**Re: Zoning By-law Amendment ZBA 01/16 (D14 TO)
Draft Plan of Subdivision D12 23T-16001
2nd Submission
Bonnarrow Meadows – Rockwood
Project No.: 300035946.0000**

Our current submission comments are listed in the table below (the “Re” refers to the number in previous submission. Comments on a drawing should be reflected on all drawings.

APPROVED  DIRECTOR OF ENGINEERING DATE: May 6/05	CITY OF BURLINGTON ENGINEERING DEPARTMENT	METRIC SCALE: N.T.S.
STANDARD ROADWAY SECTION FOR 18m ROAD ALLOWANCE - SIDEWALK ONE SIDE		DWG. NO. S-18

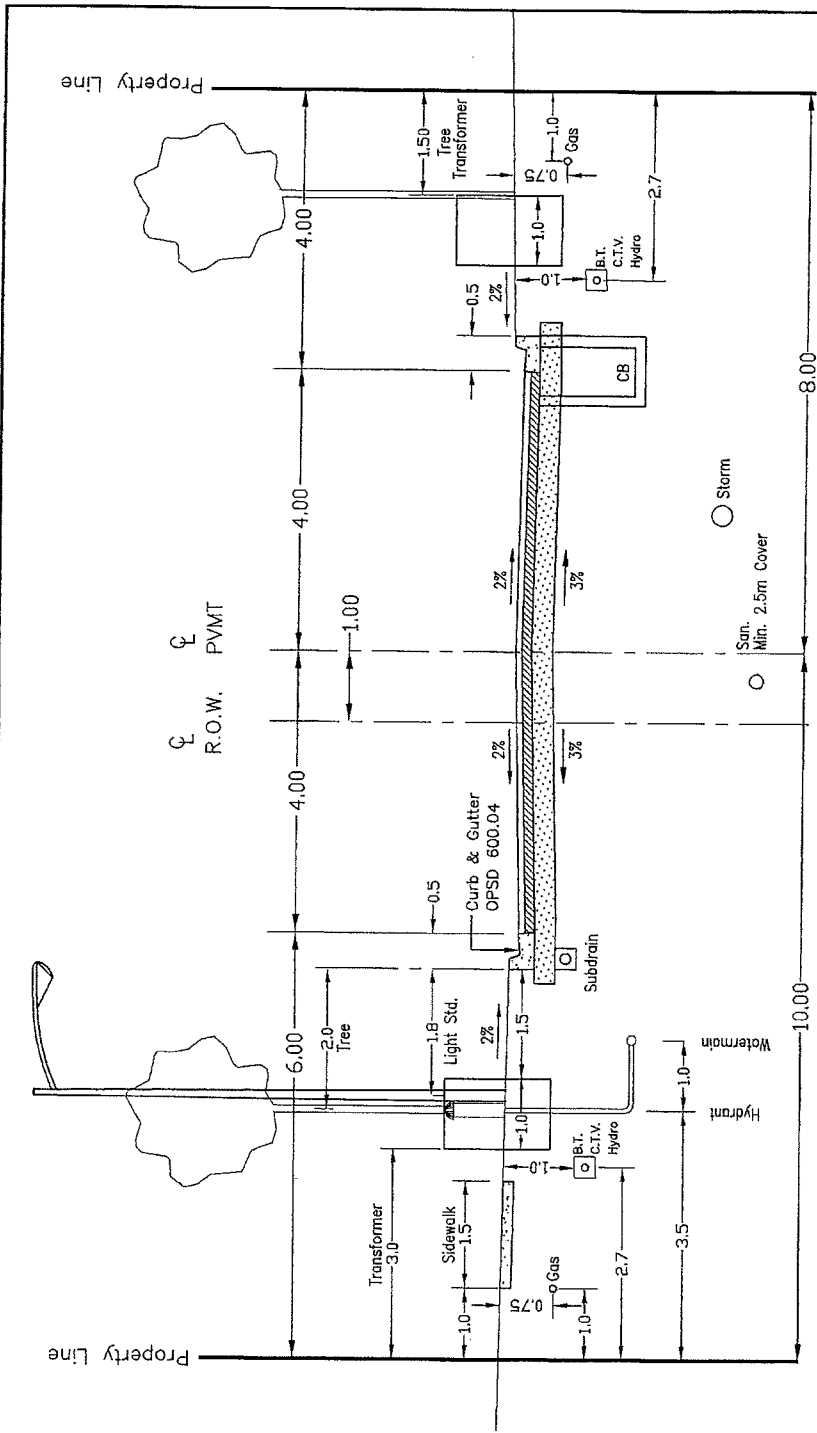
2.3	1.3	<i>In the pre-consultation meeting it was requested to have the 20 m ROW extends north to the limit of the townhouse block 163. Please review. It should also be noted that a new typical 18 m ROW detail will need to be established since the Township currently does not have one. Particular attention will need to be made to tree placement in relation to services.</i>
		The 20 m ROW was extended to the north limit of the townhouse block 163. Further discussions have taken place with the Public Works department and we are suggesting using the City of Burlington Dwg. No. S-18 as an example of an 18 m wide ROW. See attached.
